MEMORANDUM

From:	Built Heritage Officer	Service:	Green Infrastructure
Application No.	253038	Site Visit Made:	No-however in light of details is needed.
Address:	The Old Cottage, Pearson Road, Sonning, RG4 6UH.		
Proposal:	Application for submission of details to comply with the following condition of planning consent (232278) dated 9/1/2024. Condition 4 relating to structural repairs safeguarding special architectural or historic interest.		
Relevant built heritage condition text.	4. Except for the opening up works previously specified, works are not to be undertaken to make structural repairs to historic timbers and masonry work to each of the building's elevations until a method statement outlining the nature and extent of the repairs to be undertaken for each individual elevation has been submitted to and approved in writing by the local planning authority. Structural works are then be undertaken in accordance with the details as approved

Condition 4 should **not** be discharged. The submitted details include elements that differ from, or go beyond, those approved under consent 232278. Further clarification is required, particularly regarding the western elevation.

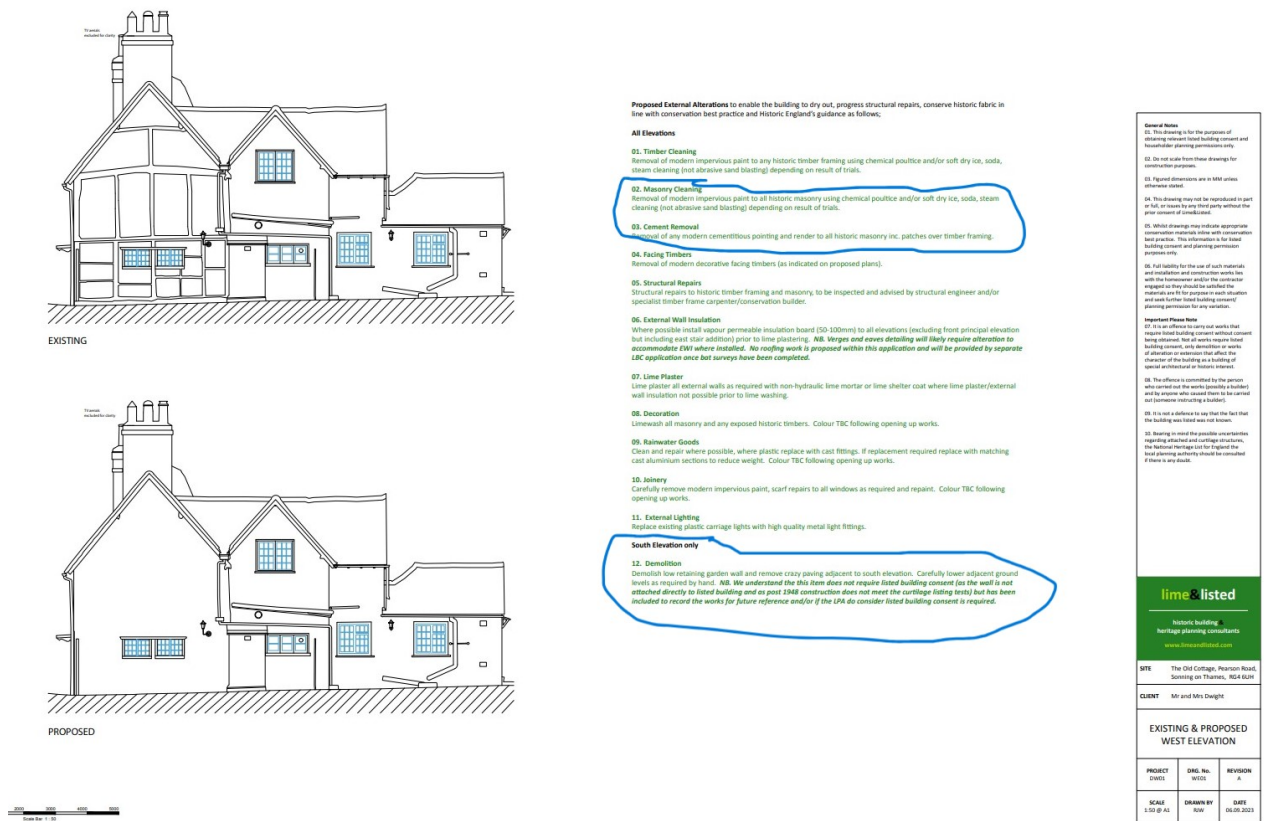
The proposed removal of ground-floor masonry infill and the associated need to prop the gable also raises structural risks. The structural engineer's report identified the dropped first-floor ceiling beam, which has separated from the gable wall, but this was not included in the approved scope of works. Further intervention may require additional consent.

Approved Existing & Proposed Elevation, drawing no. WE 01 Rev. A

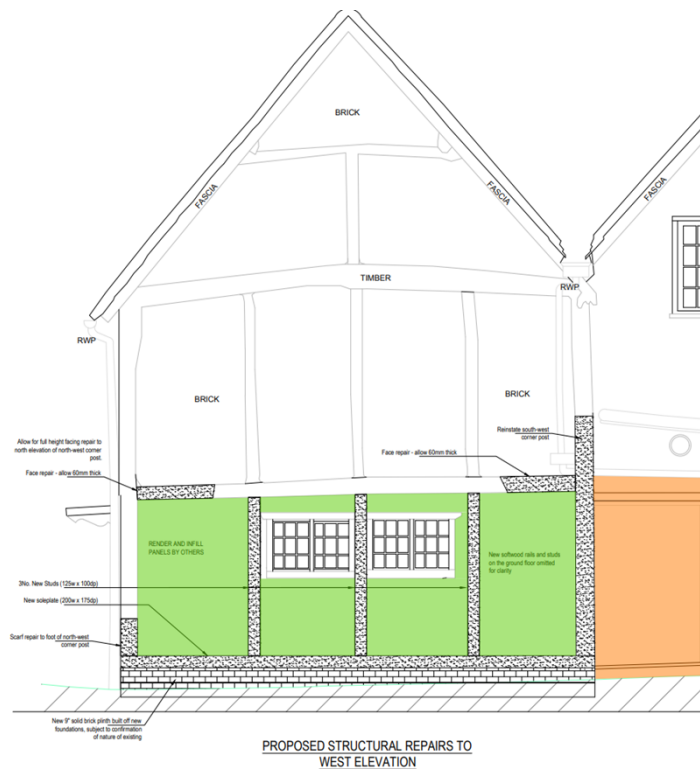
The submitted information raises several concerns, especially in relation to the western gable end. The scope of works described does not fully align with the approved details under Condition 4 of consent 232278. The method statement proposes removing the infill masonry (shaded green on drawing 246714-02-P1) and the modern boiler housing (shaded orange) to allow access for structural repairs. However, neither element forms part of the approved works shown on drawing WE.01 Rev. A.
